UNITED STATES PATENT AND TRADEMARK OFFICE

APPLICATION NO.	FILING DATE	FIRST NAMED INVENTOR	ATTORNEY DOCKET NO.	CONFIRMATION NO.
09/830,030	04/20/2001	Yukihito Ichikawa	791_328	9377
25191	7590	10/30/2008		
BURR & BROWN PO BOX 7068 SYRACUSE, NY 13261-7068			EXAMINER LEUNG, JENNIFER A	
			ART UNIT 1797	PAPER NUMBER
			MAIL DATE 10/30/2008	DELIVERY MODE PAPER

Office Action Summary

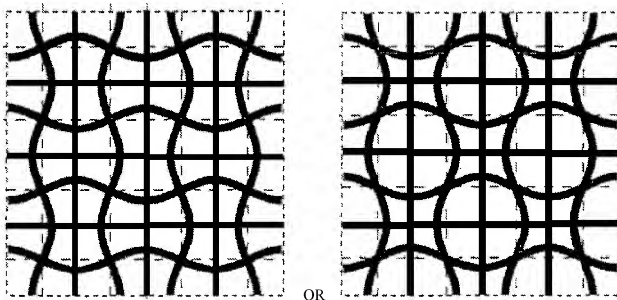
Secondly, the Examiner maintains that the honeycomb structures shown in FIGs. 3 and 4 (in the X-Y plane) would not produce the Y-Z plane illustrated in FIG. 28B, in which each recession faces an opposite recession, and each protrusion faces an opposite protrusion, with the flat wall therebetween. In fact, the honeycomb structures shown in FIGs. 3 and 4 would both produce the Y-Z plane illustrated in FIG. 28A. In order for the Y-Z plane in FIG. 28B to occur, the corresponding X-Y plane of the honeycomb structure would have to look like, for example,

However, neither of the above illustrated configurations is supported by the original disclosure. FIG. 28B and its description thus constitute new matter.
